Re: the Application of Tadahiko HISANO
For: EXTERNAL STORAGE DEVICE AND METHOD OF ACCESSING SAME

REQUEST FOR APPROVAL OF DRAWING CORRECTIONS

FIG.1

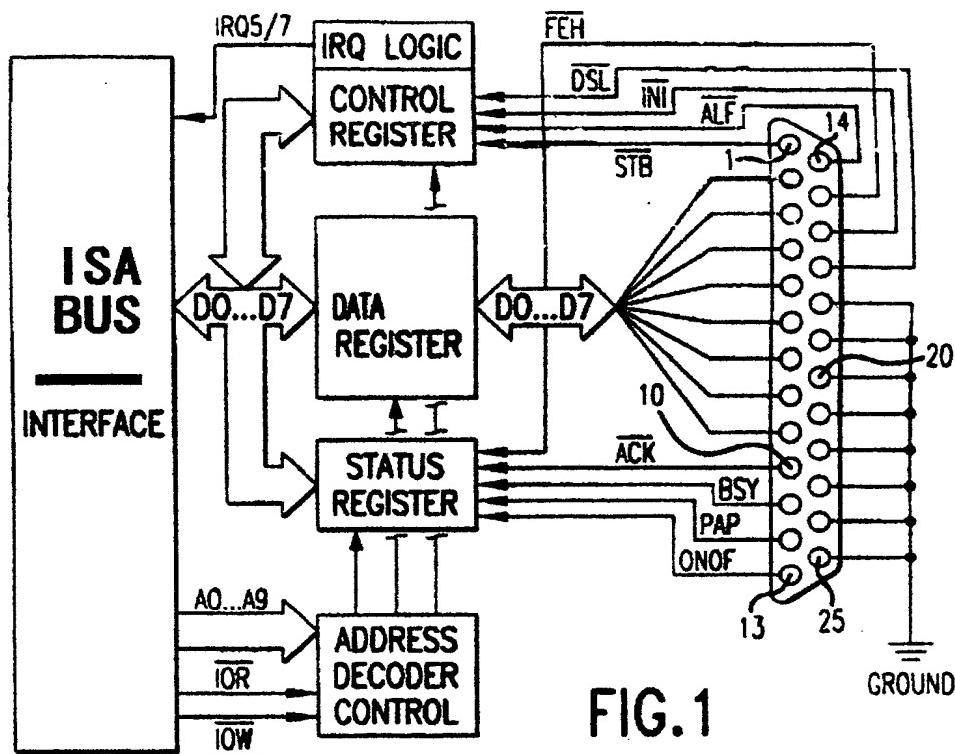
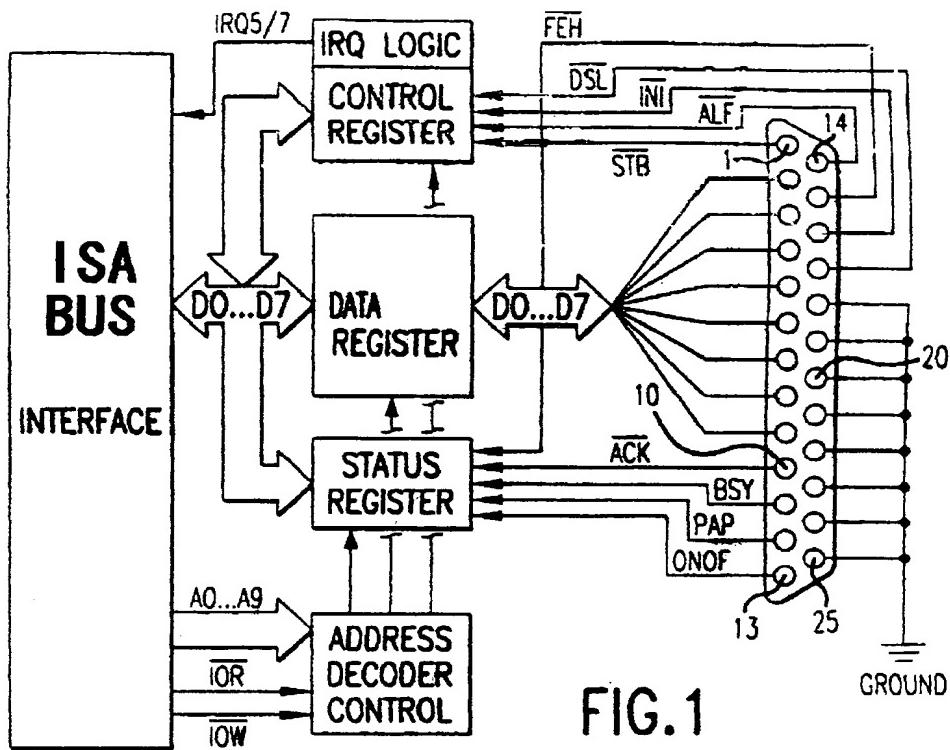
Fig. 1 corrects typological error "PC INTERFACE" to --ISA BUS INTERFACE-- to adjust to page 6 line 15 - page 7 line 25 of the specification.

FIG. 5

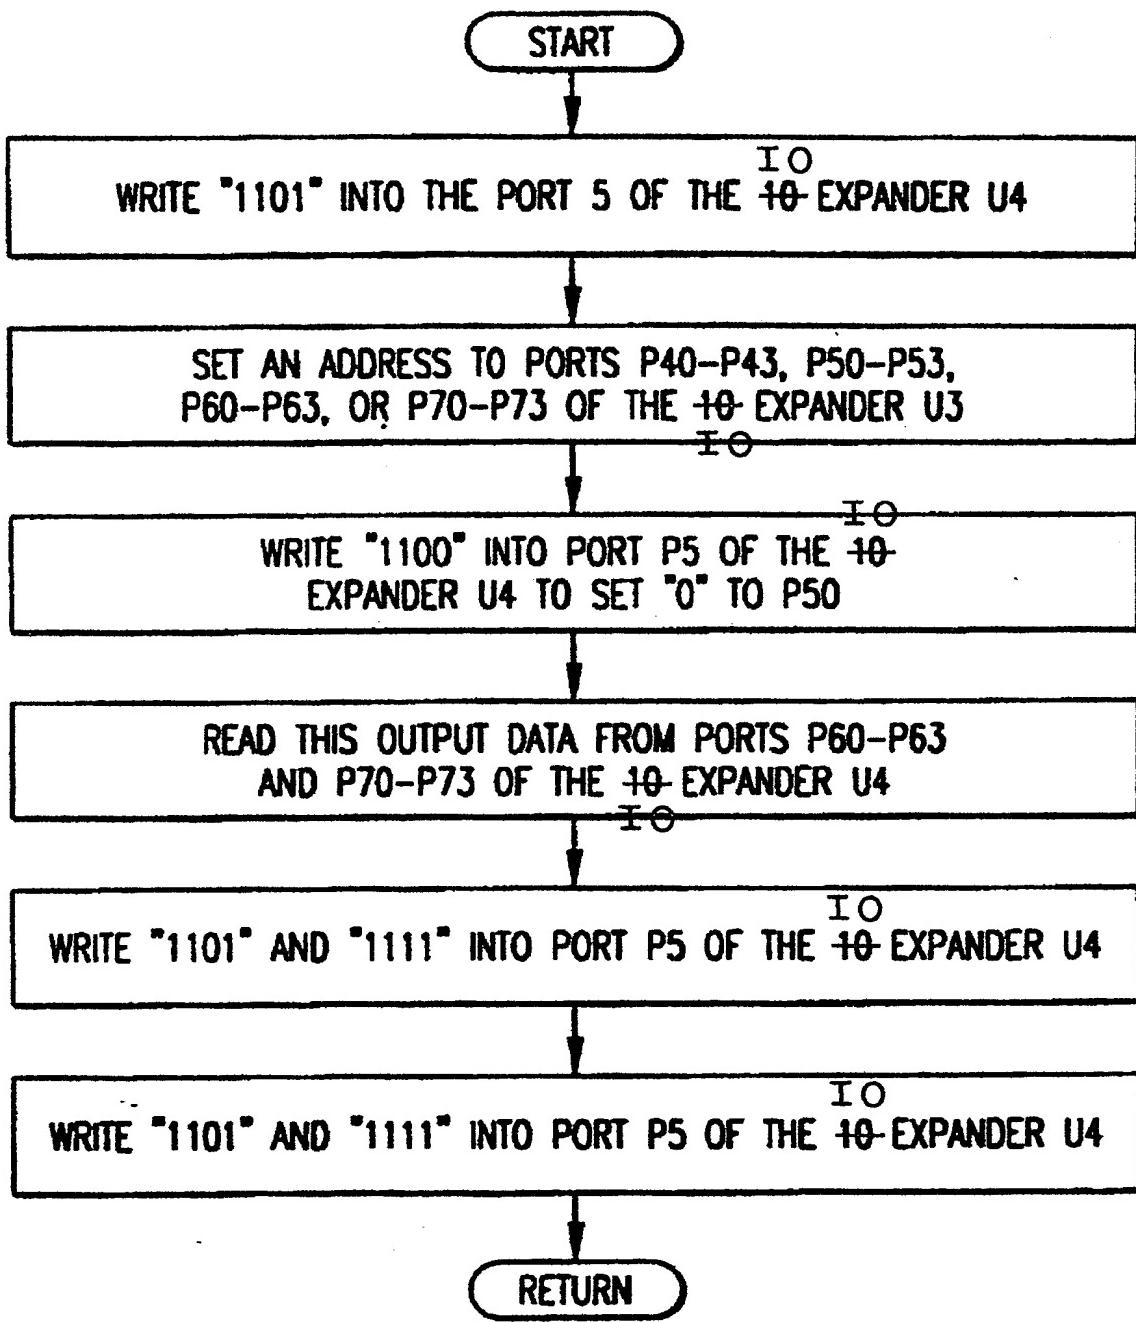
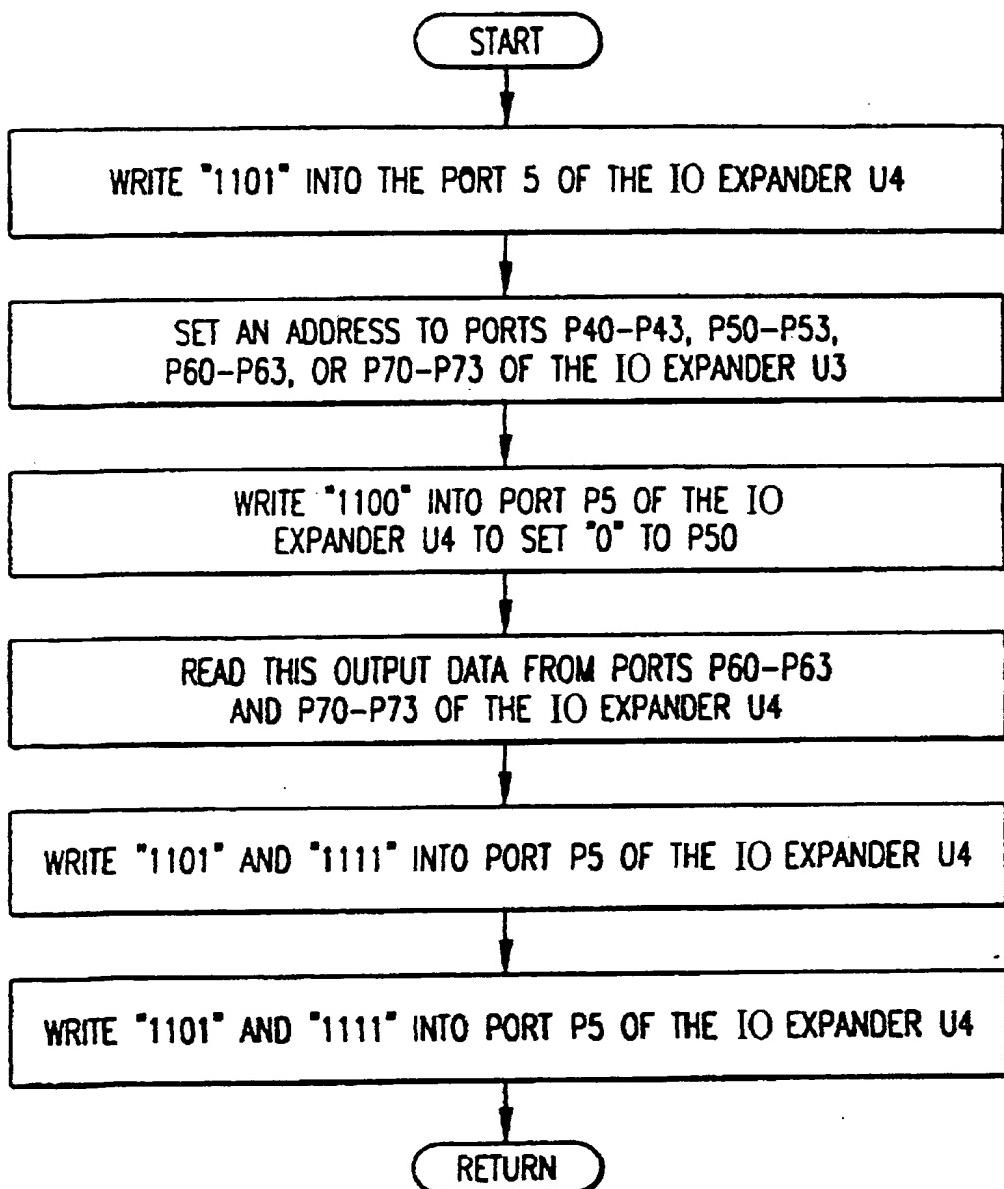
Figs. 5, 6, 8 and 9 correct typological error "10" to --f0-- and delete the unnecessary wording "TO SET "0" TO P50", "TO SET "0" TO P52", "TO SET "1" TO P52", "TO SET "1" TO P50", and "RETURN TO THE INITIAL STATUS".

FIG. 19

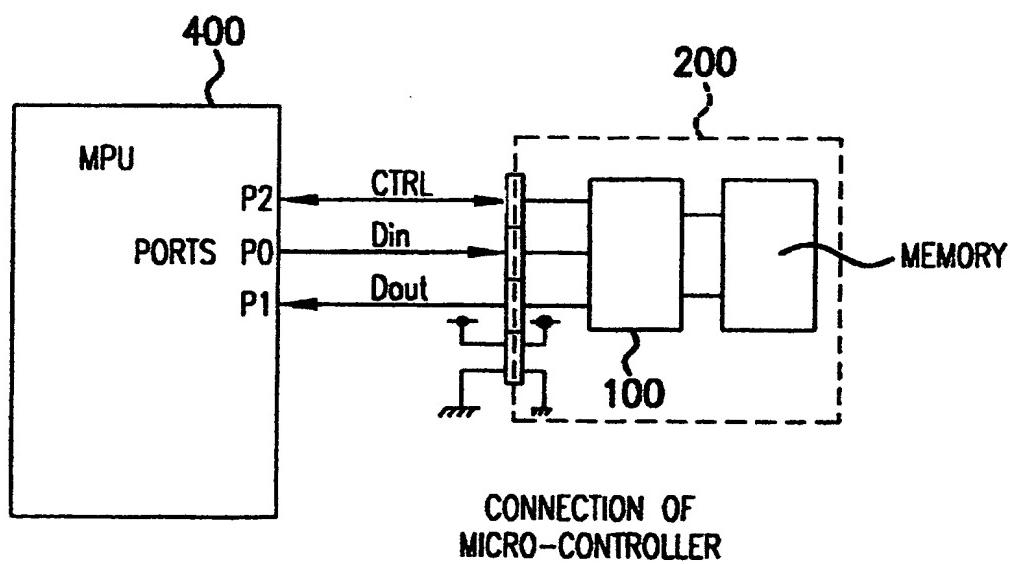
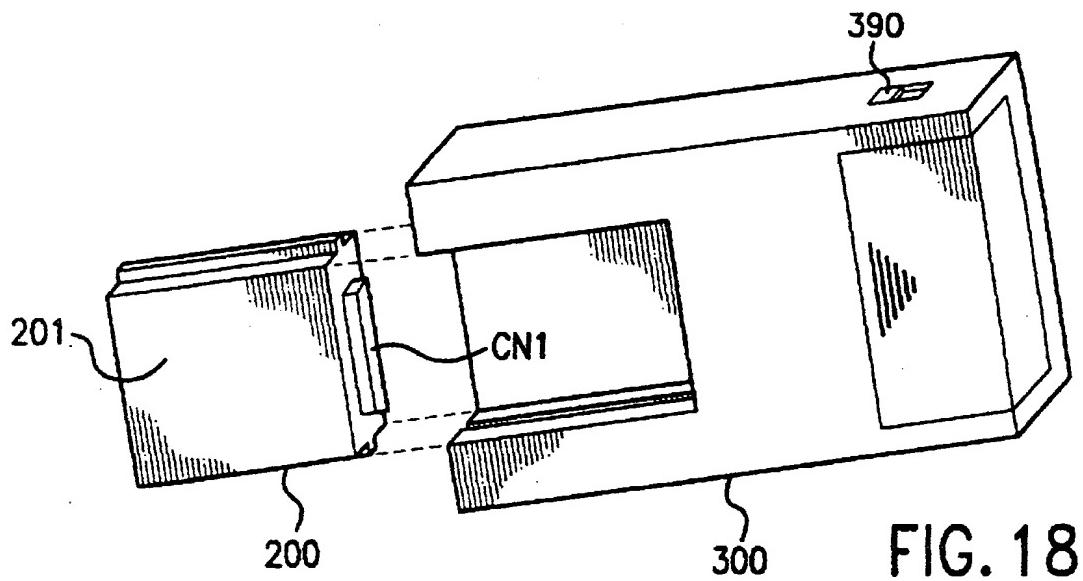
Fig. 19 and 25 corrects drawing error of the arrow and Fig. 27 correct typological error "196" to --186--, to correspond to those filed with PCT parent Application
